ADDENDUM #1

Reference: Parleys Maintenance Station #234 Improvements
Utah Department of Transportation - Utah
DFCM Project No. 08211900

DFCM Project No.: 08211900
Archiplex Group Project No.: 0728.02

ADDENDUM NO. 1 to the Contract Documents for the Construction of UDOT Maintenance Station #2434, Parleys Canyon, Utah.

AE201

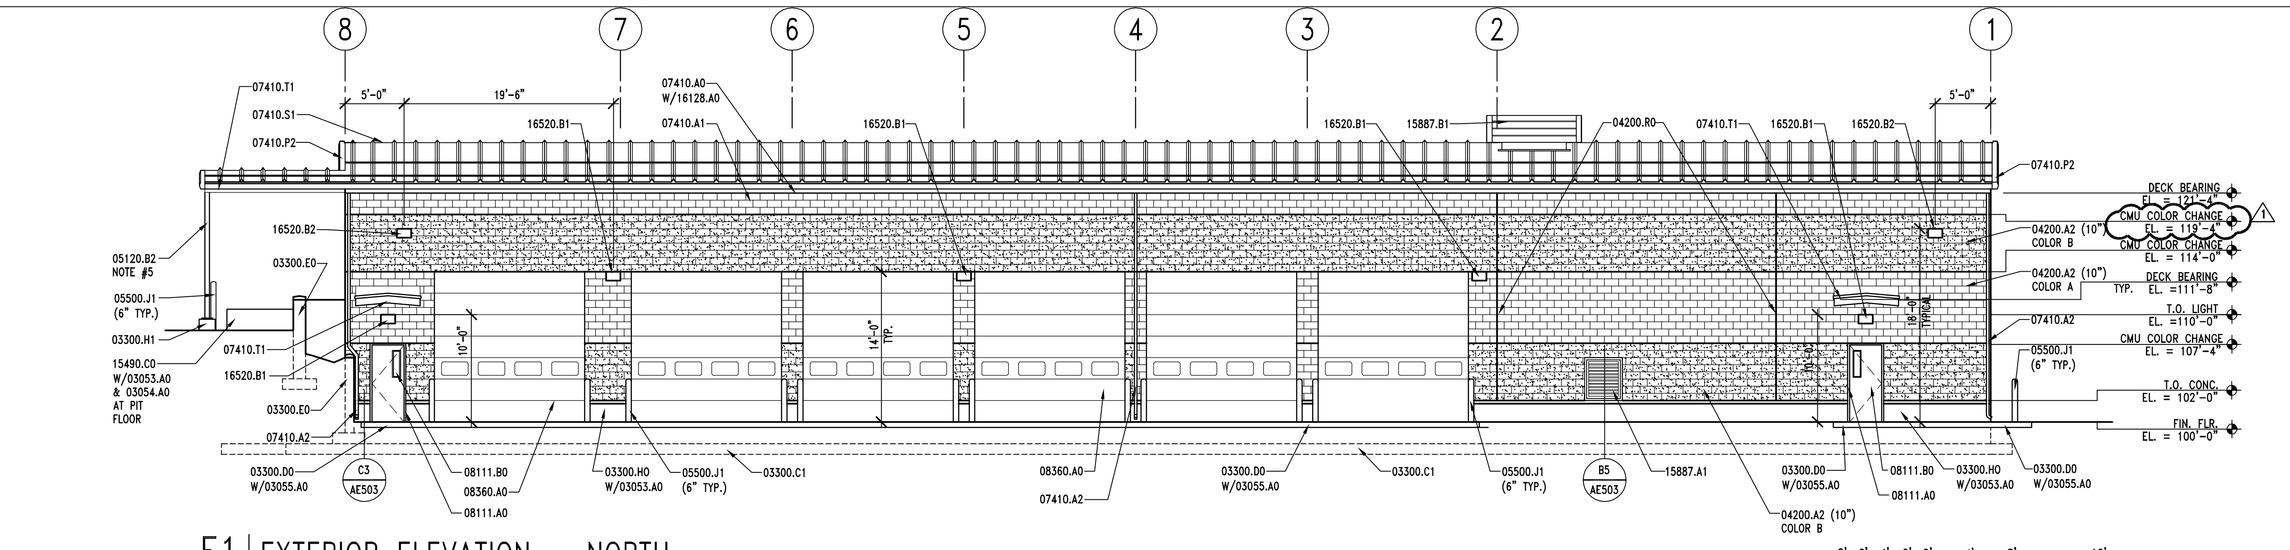
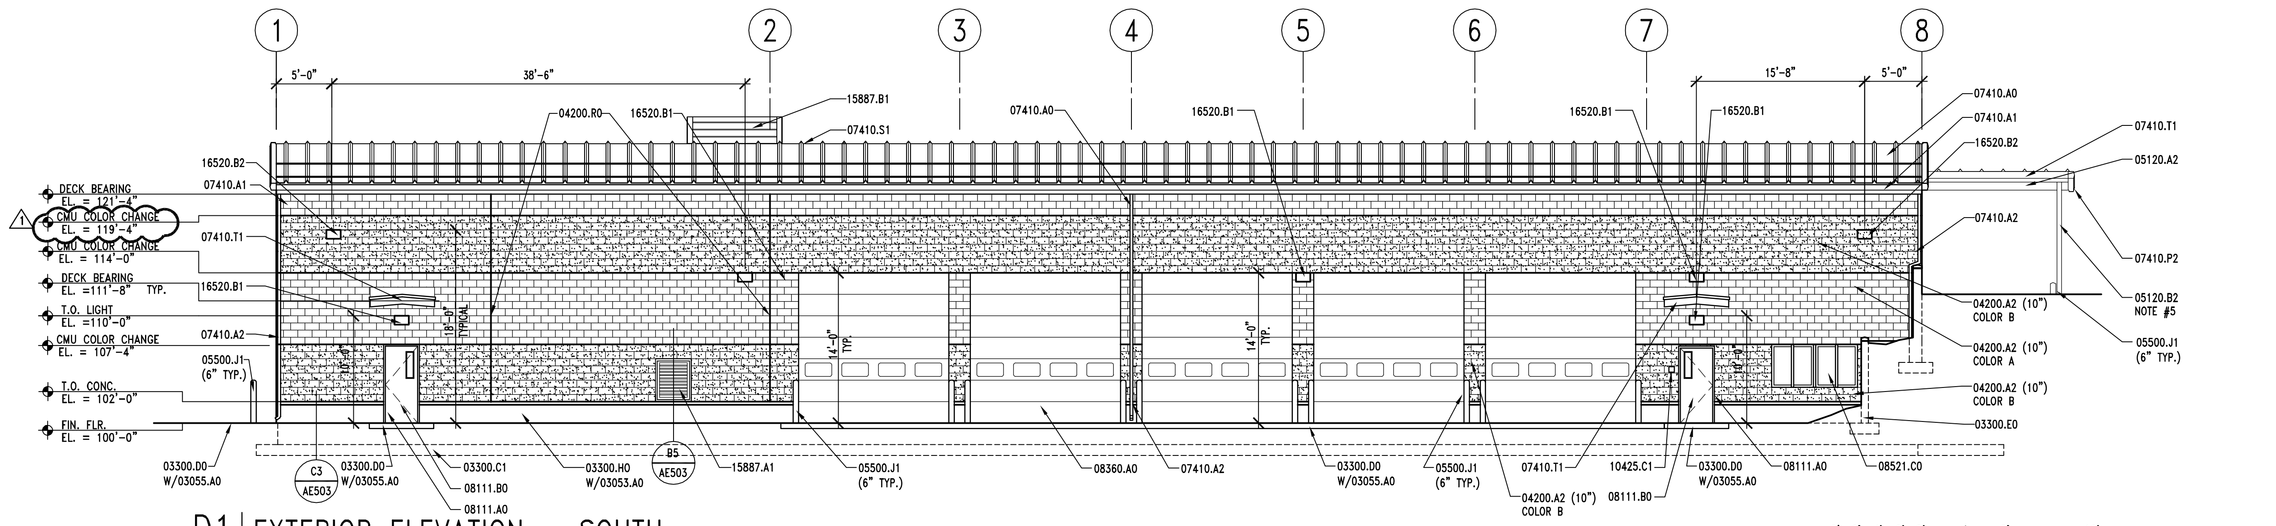
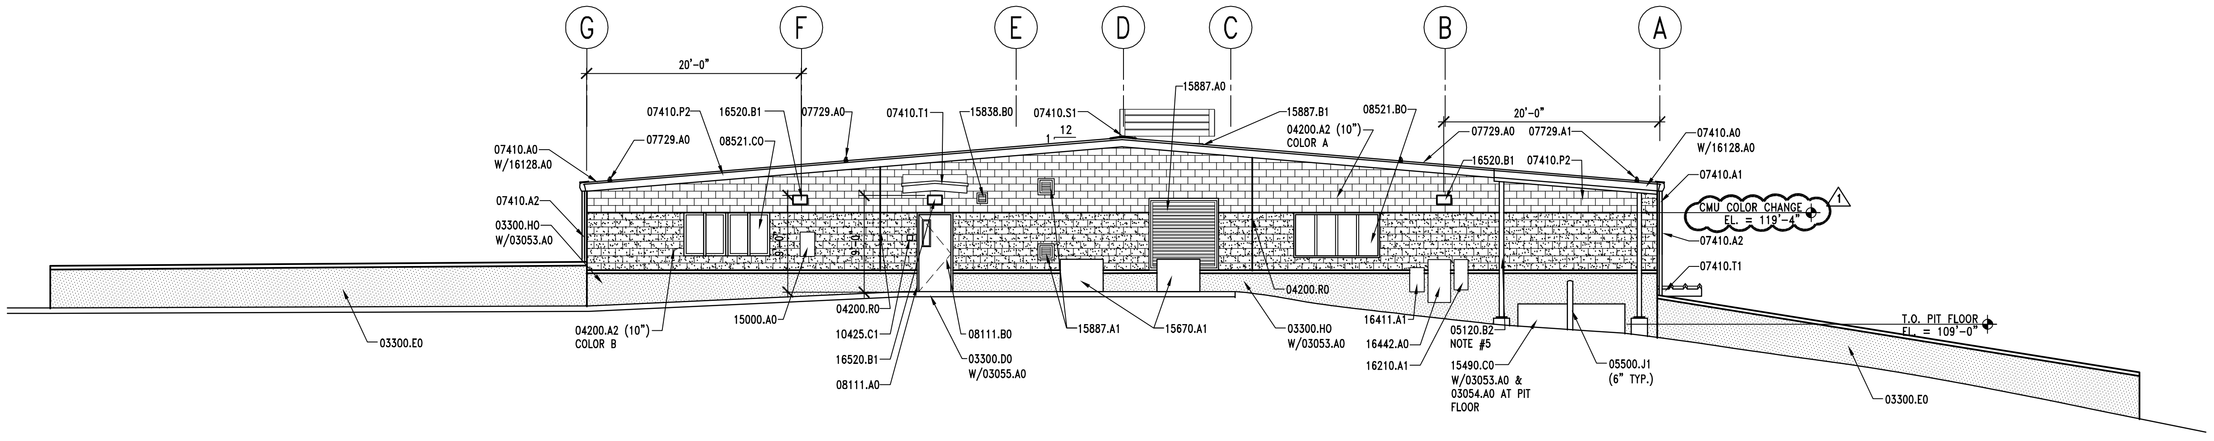
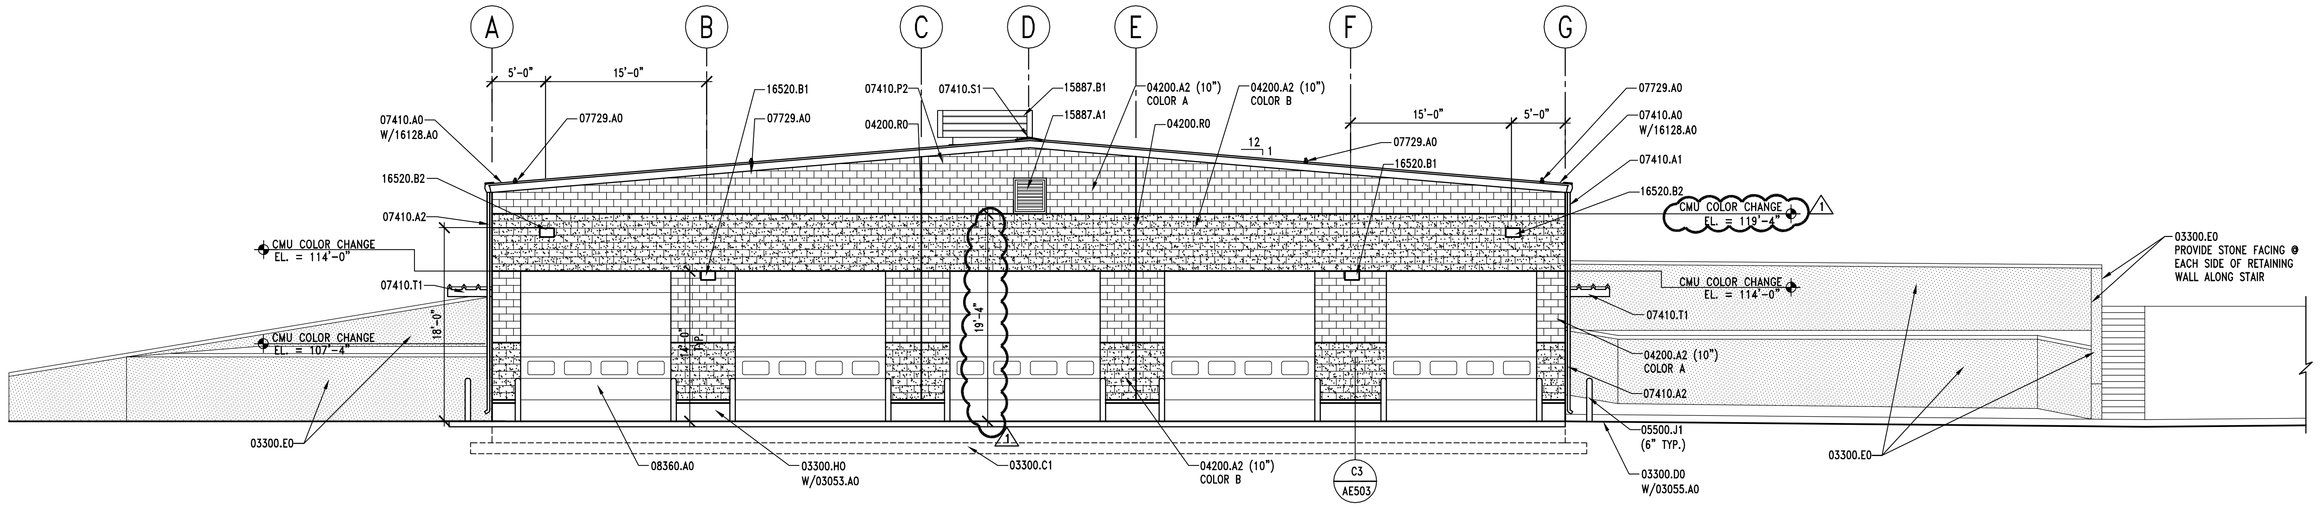
Sheet AE201:

a. Change retaining wall construction from Cultured Stone to colored concrete with form liner.
b. Added color selection for roof, rain gutters, downspouts and 2 colors of cmu.
c. Changed color “B” cmu to split face CMU.
d. Revised locations of CMU Color Change

E3 BUILDING SECTION

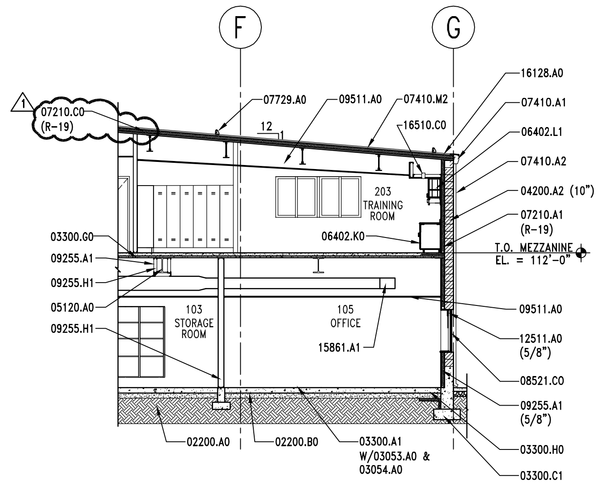
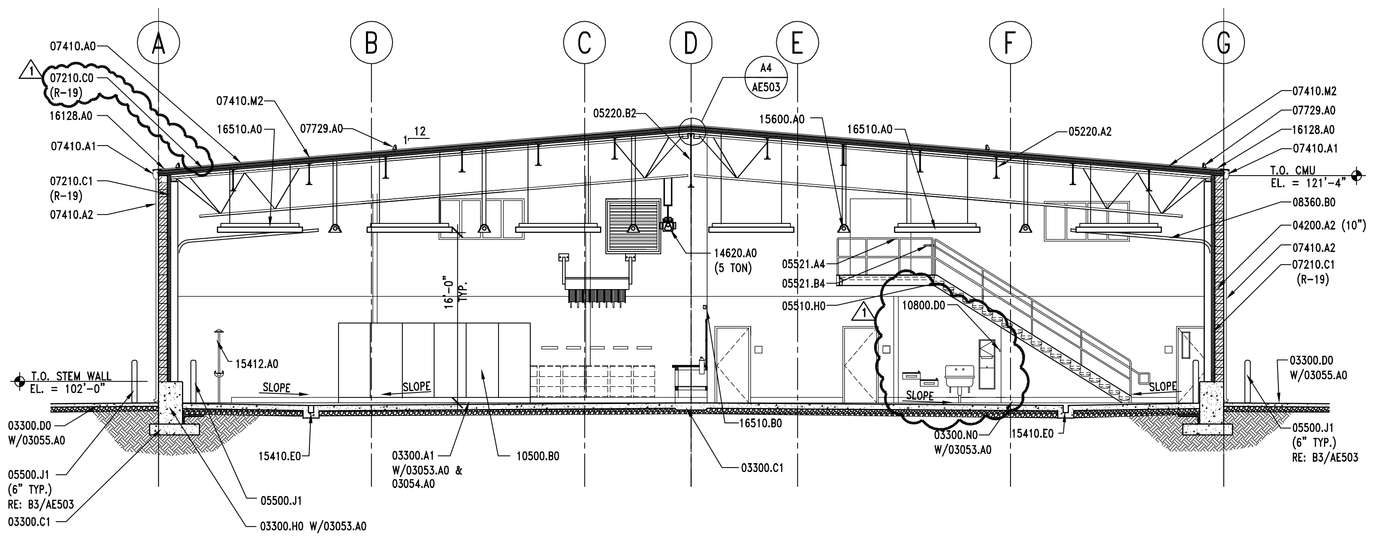
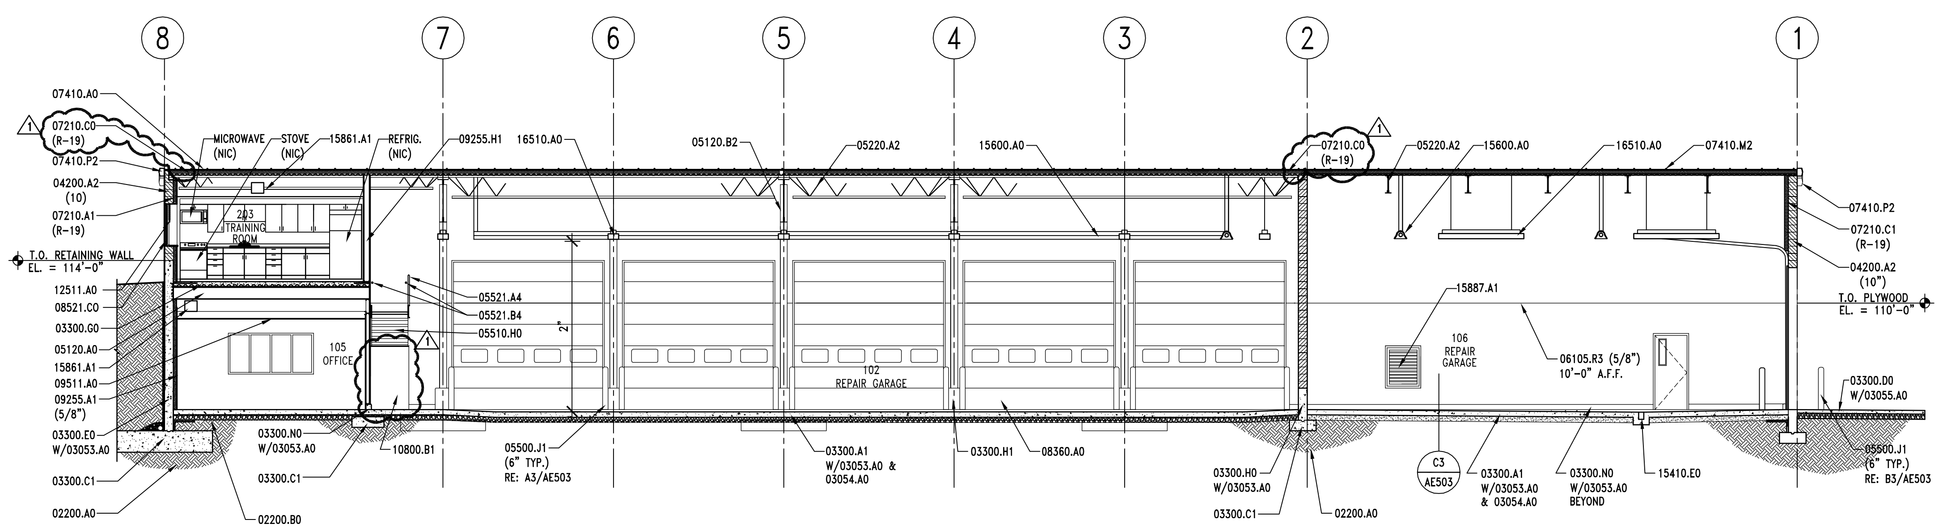
Sheet AE301:

a. Changed Keynote 07210.B1 to 07210.C0.
b. Revised sections to reflect change in drinking fountain.

B2 ACCESSIBLE DRINKING FOUNTAIN DETAIL

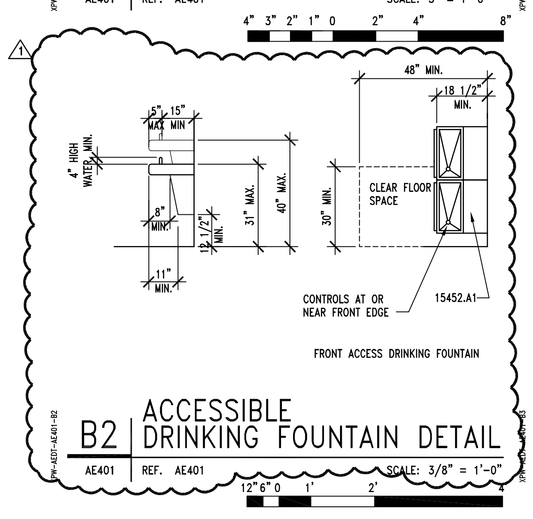
Sheet AE401:

a. Revised enlarged plan to reflect Bi-level drinking fountain.
b. Revised detail B2/AE401.

B3 | STAIR ELEVATION

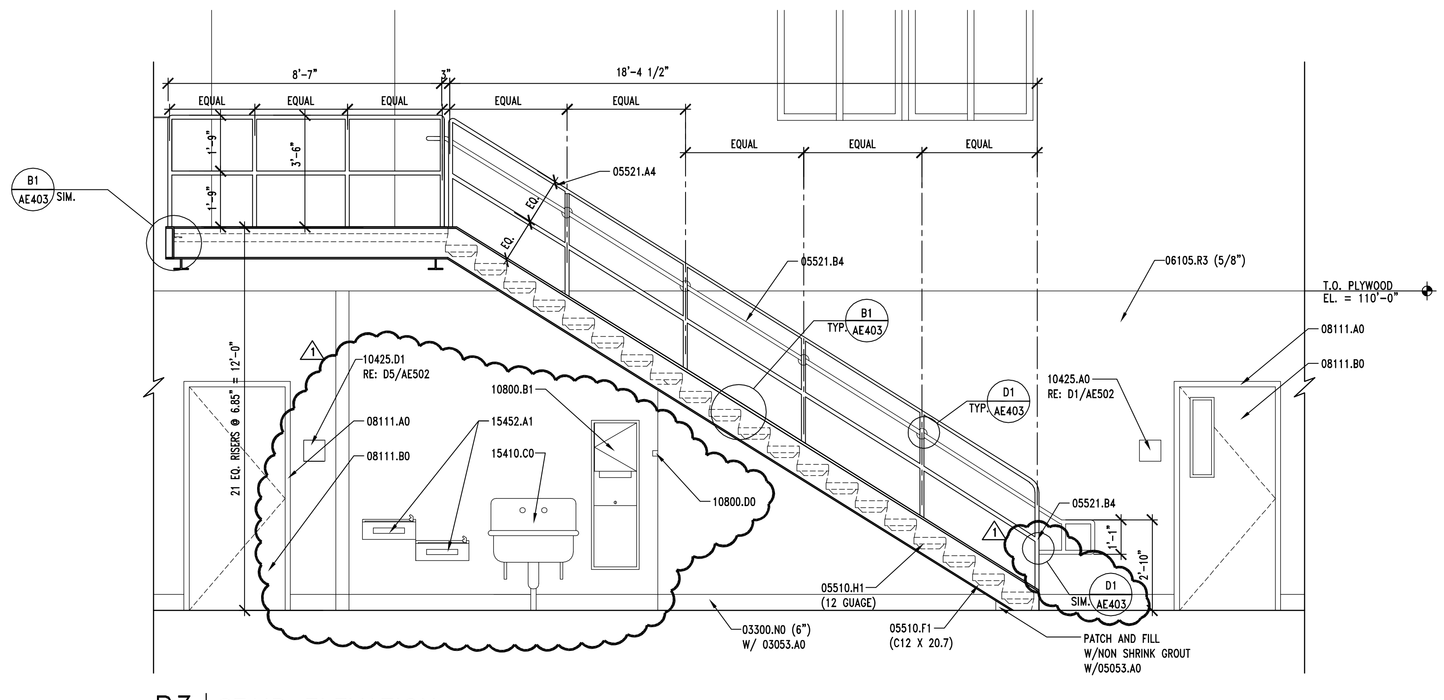
Sheet AE403:

a. Revised B3 & C3 to reflect Bi-level drinking fountain revision.
b. Added detail reference to show handrail connection to vertical pipe.

A1 WALL TYPES

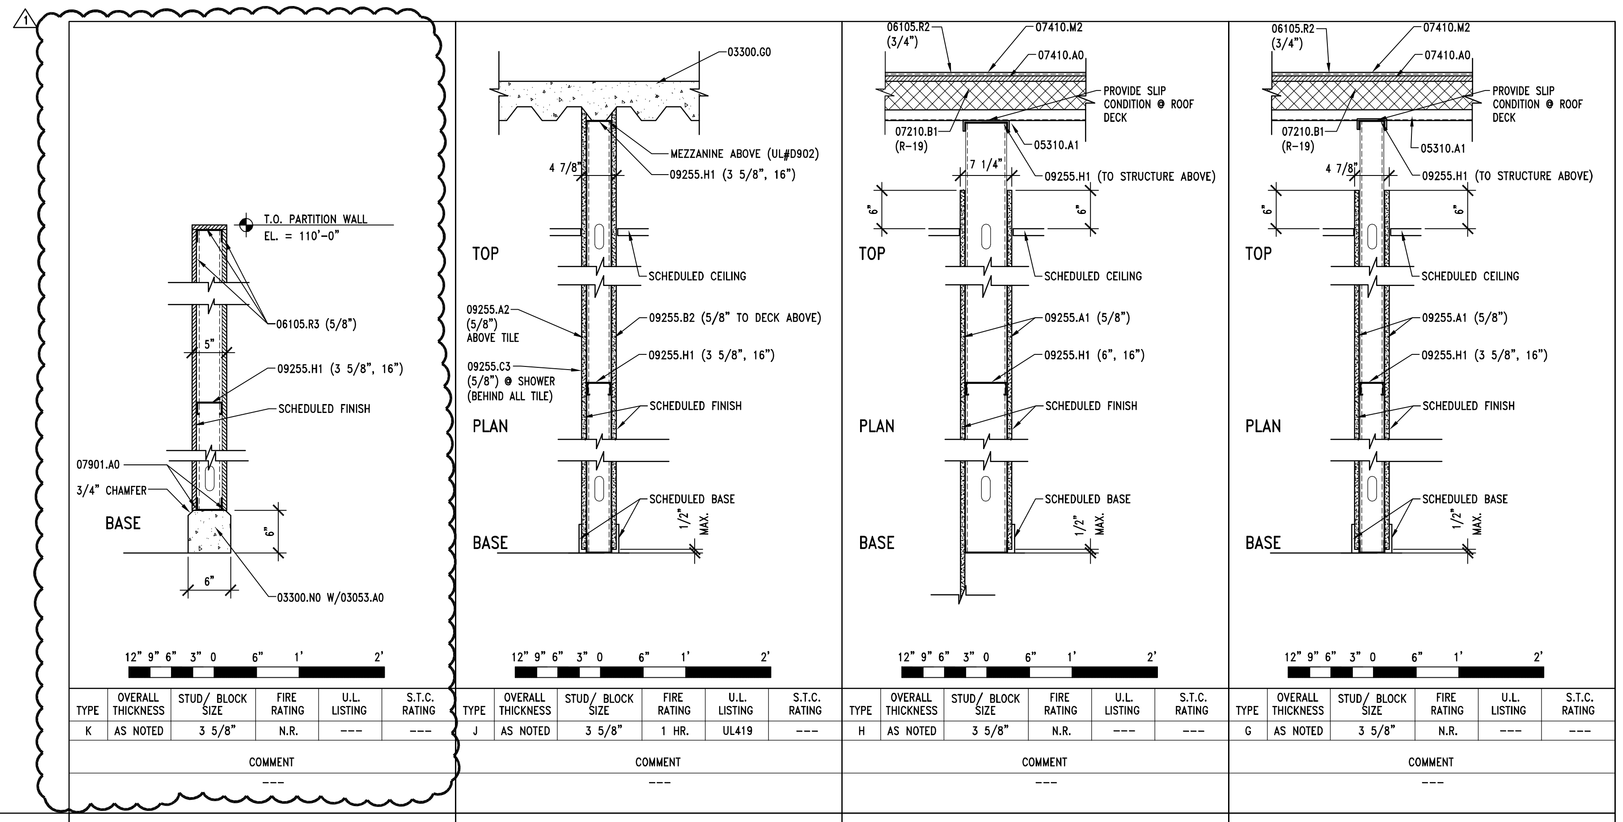
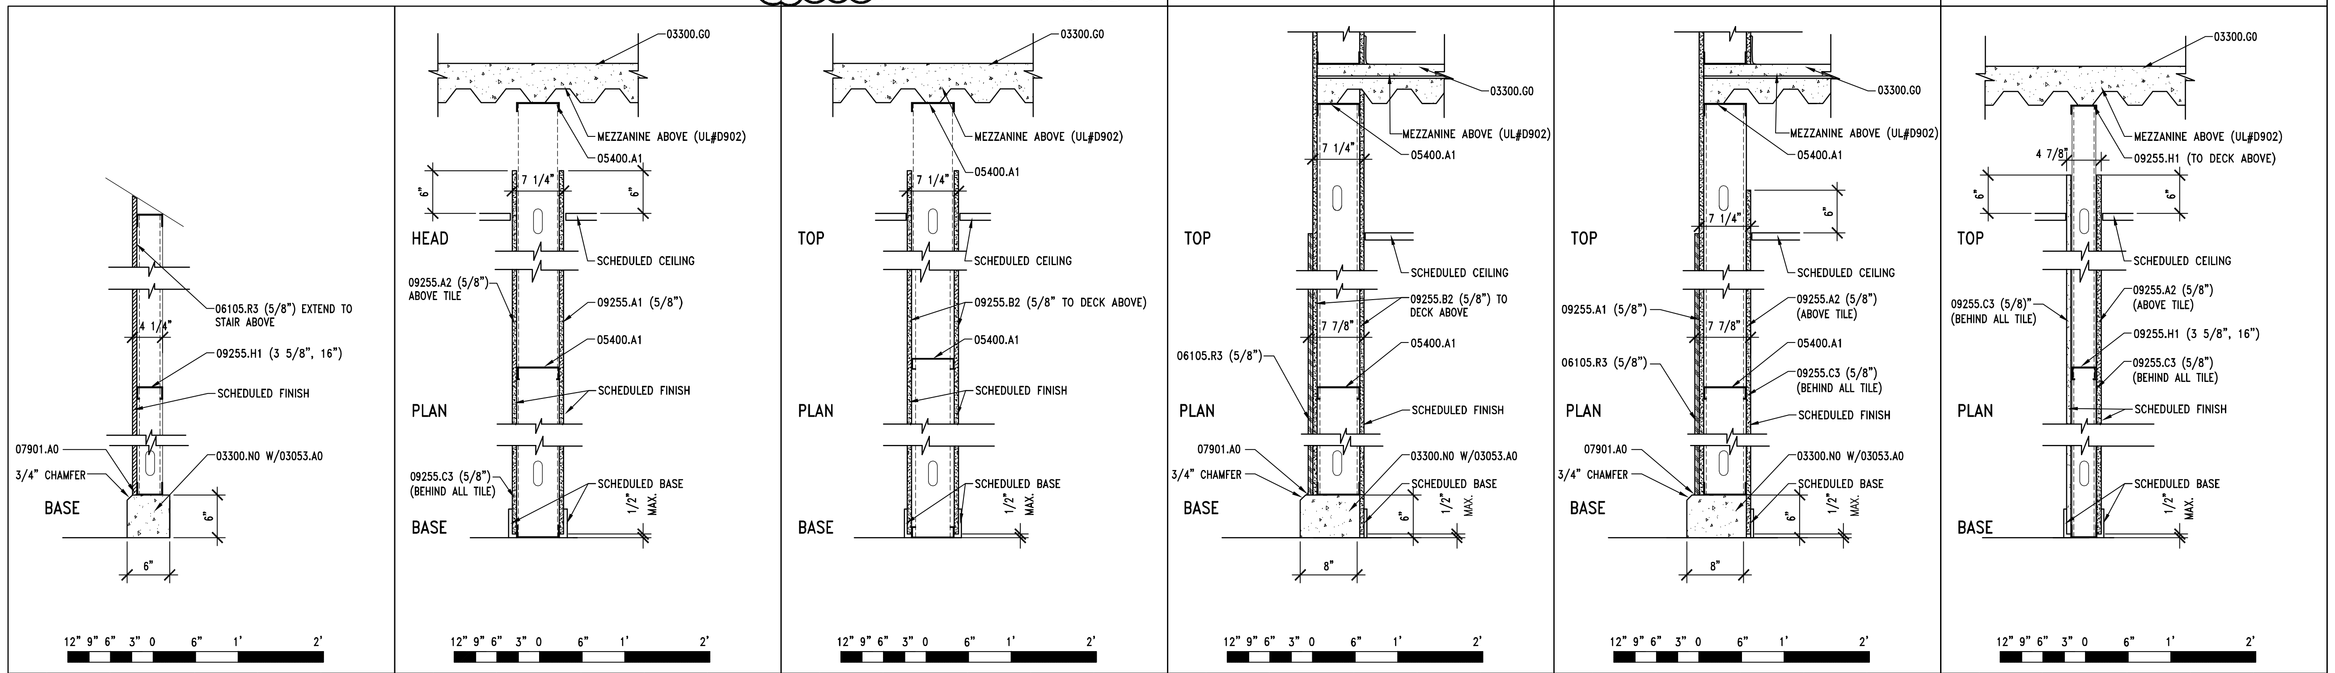
Sheet AE501:

a. Added new wall type “K”.

C3 | LAY-IN PANEL EDGE DTL.

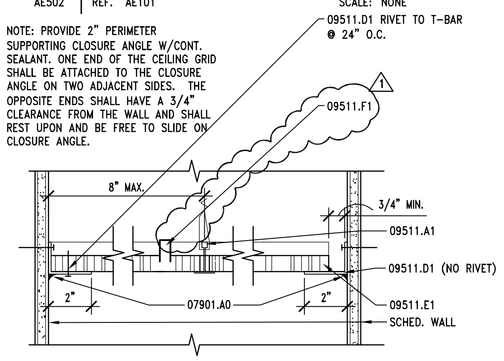
Sheet AE502:

a. Revised detail C3 to show spreader bar as per code official request.
